Countries:	RUSSIA, AUSTRALIA, CANADA, COLOMBIA, UNITED STATES, MEXICO, PUERTO RICO, KOREA, NEW ZEALAND	**Document ID**:	IK1200541
Availability:	ISIS, FleetISIS	**Revision**:	3
Major System:	ENGINES	**Created**:	10/7/2010
Current Language:	English	**Last Modified**:	8/1/2014
Other Languages:	Français, Español,	**Author**:	Mark Ehlers
Viewed:	8782

Title: Air Control Valve (ACV): Audible Air Leaks, 2 vs 3 Mount Versions and Updated 15L Version

Applies To: EPA 10 MaxxForce 11L, 13L, 15L, EPA 10 13L HDOBD, N13 with SCR Engines

Two and Three bolt versions of this valve exist (see images):

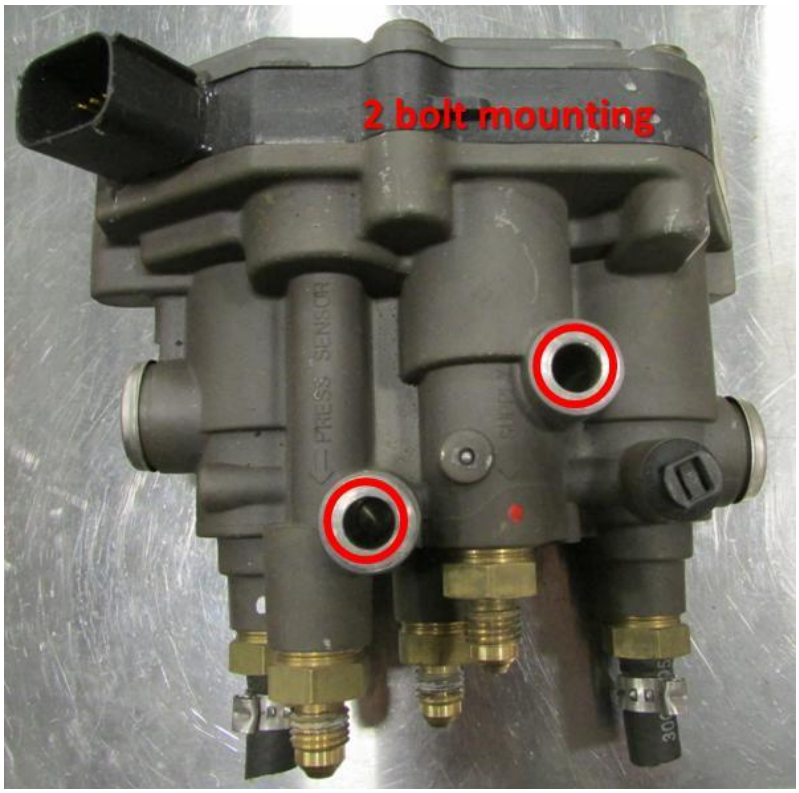
- 2 bolt versions of the ACV **SHOULD NOT** be retrofitted to 3 bolt versions **UNLESS THE VALVE HAS FAILED**
- A 2 bolt ACV can be attached to a EGR cooler that has 3 holes (for ACV attachment)
- A 3 bolt ACV can be attached to a EGR cooler that has 2 holes (for ACV attachment)
- Replacement of 2 bolt versions (to 3 bolt version) is not covered in warranty unless the 2 bolt version has failed or you have been directed to replace the ACV in a field campaign.

15L upgraded ACV (applies to MaxxForce 15 only):

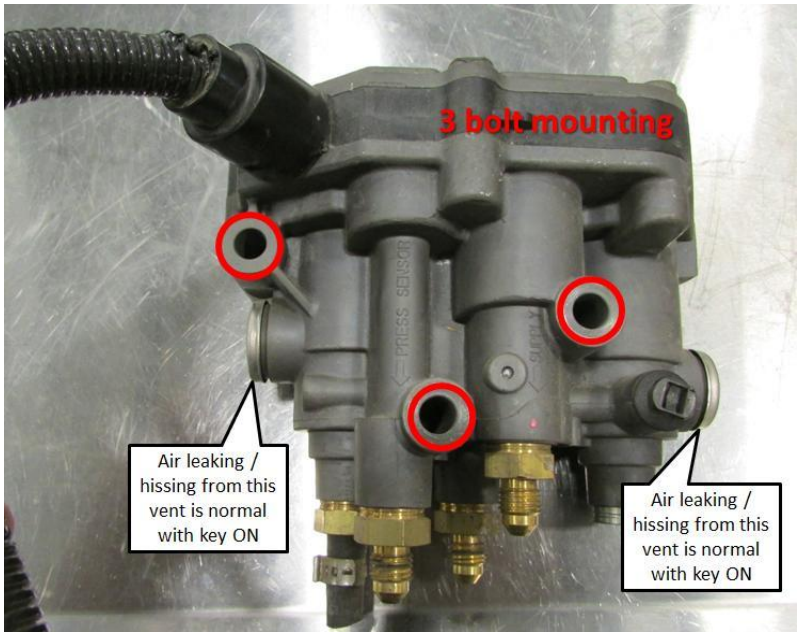
- The PDC's inventory of 15L ACV's have been upgraded with an extension harness that has been made with gold terminals, lubricated with dielectric grease, and had the connection sealed with red shrink tubing.
  - This upgrade improves the reliability of the ACV by eliminating electrical connection fretting
- The upgraded valves have a "U" written on the box's part number label (image)
- The upgraded valve has harness routing instructions in the box (image)
- The upgraded valve looks like this (image)
- Only install the upgraded valve if you are certain that the old valve has failed
- Closely inspect the engine harness for spread or fretted terminals before installing a new ACV
  - a damaged engine harness ACV connector can be repaired with kit 3014682C91 (instructions included)
